Model: Kir-C Paper Tray Unit /2 tray (PS450)		Date: 26-Jun-01	No.: MB384001
Modified Article: Parts Catalog Correction		Prepared by: K. Miura	
From: Technical Services Dept., GTS Division			
Reason for Modification:	☒ Parts catalog correction ☐ To facilitate assembly ☐ Part standardization	☐ Vendor change ☐ To improve reliability ☐ Other	☐ To meet standards ()

Model: Kir-C Paper Tray Unit 2-tray (PS450)		Date: 27-Dec-02	No.: MB384002
Modified Article: Transport Motor		Prepared by: K. Miura	
From: Technical Services Sec. Service Planning Dept.			
Reason for Modification:	☐ Parts catalog correction ☐ To facilitate assembly ☒ Part standardization	☐ Vendor change ☐ To improve reliability ☐ Other	☐ To meet standards ()

Model: PS450	Date: 16-Mar-06	No.: MB384003a
--------------	-----------------	----------------

Modified Article: Prevention from being falling down		Prepared by: Hiromoto Saitoh	
From: 1st Tech. Support Sec. Service Support Dept.			
Reason for Modification:	☐ Parts catalog correction ☐ Vendor change ☐ Other ☐ To facilitate assembly ☒ To improve reliability ☐ To meet standards ☐ Part standardization ☐ Product Safety ()

Page11

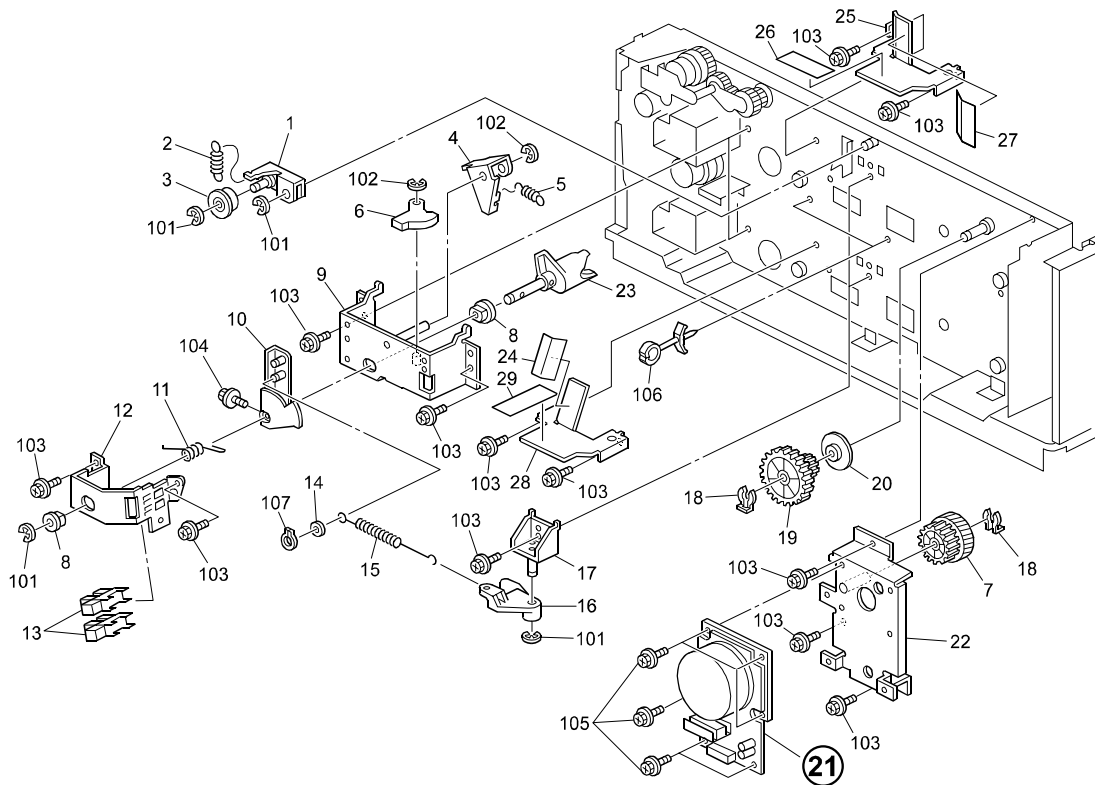
Please correct your Parts Catalogs as follows:

- Delete the following -

Part number	Description	Q'ty	Index	Note
06230140E	Spring Pin – 3x14mm		108

-Illustration- P.2

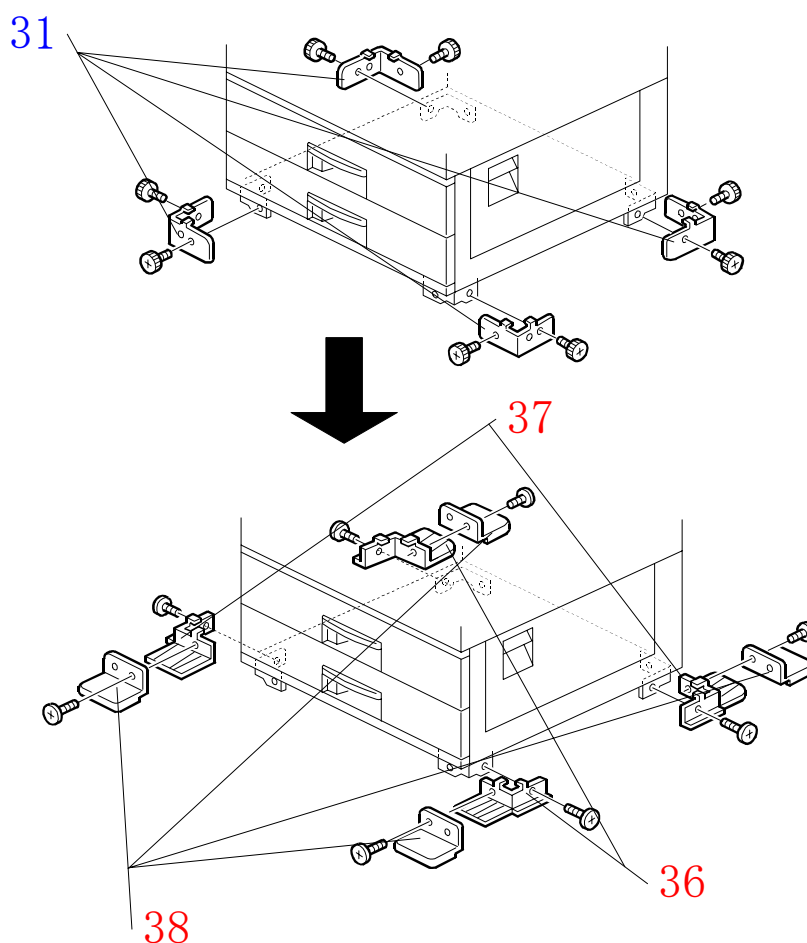
Old part number	New part number	Description	Q'ty	Int	Page	Index	Note
B3846280	-	Unit Holder	4 – 0	-	2	31	
-	B8066117	STAND COVER	0 – 4	-	2	38	
-	B8066119	SUPPORT BRACKET	0 – 2	-	2	37	
-	B8066125	SUPPORT BRACKET	0 – 2	-	2	36

Change: The unit holders were replaced with support brackets, which are stronger.

Reason: So that the PS450 can also be installed on the PG-C1 (B229).

Note: This is necessary because the PG-C1 is bigger than Model K-C and Model R-C.
